Government of the District of Columbia Advisory Neighborhood Commission 4B

DRAFT RESOLUTION #4B-21-0905

**Opposing Concept Plan for 1000 Main Drive, NW,
Parcels A-G of The Parks at Walter Reed (HPA 21-154)**

Adopted September 27, 2021

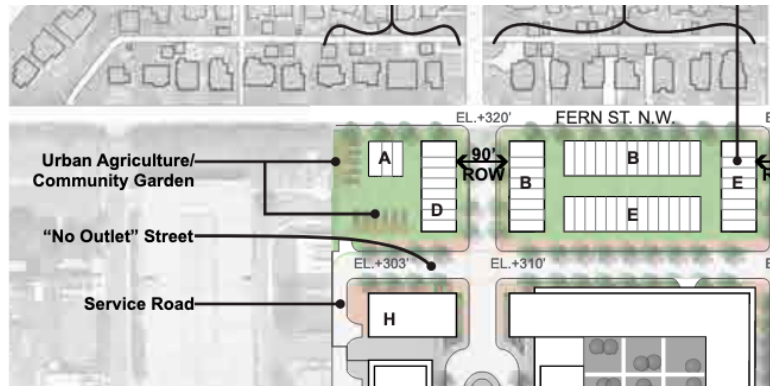
- The concept plan does not conform with the Parking Plan for the site, as outlined in the HUD-approved Final Reuse Plan, which calls for one parking space per townhome in the townhome section of these Parcels and 23 spaces and a 0.5 space/dwelling ratio for the multifamily section of these

Parcels. Final Reuse Plan, [Chapter 8, Reuse Plan, Development Guide, Parking Plan](#). These same parking ratios are outlined in the Small Area Plan. Walter Reed Small Area Plan, [Chapter 3.4 Transportation Recommendations, Parking Plan](#).

- Advisory Neighborhood Commission 4B recommends that the developer maintain the original Parking Plan contained in both the Final Reuse Plan and the Small Area Plan and use the additional green space to restore both the courtyards and urban agriculture/community garden.

Urban Mobility - Fern Street. Source: Perkins+Will.

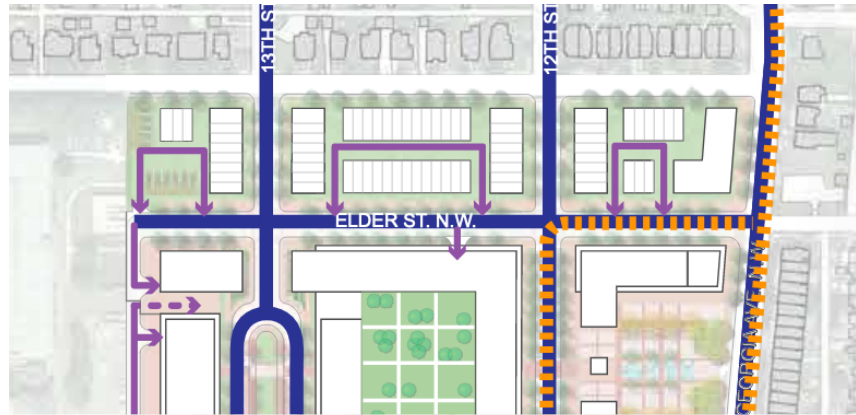
- The proposed vehicle circulation driveways are not in keeping with the Small Area Plan. Whereas the Small Area Plan envisions vehicular circulation toward Elder Street, NW, with all curb cuts and driveways confined to the Southern border of Parcels A-G, the proposed

concept plan adds curb cuts and driveways on both 12th Street, NW, and 13th Street, NW, driving vehicular traffic north out of the parcels and increasing the impact on adjacent neighborhoods. Walter Reed Small Area Plan [Chapter 3.3 Sub-Area Urban Design Principles](#).
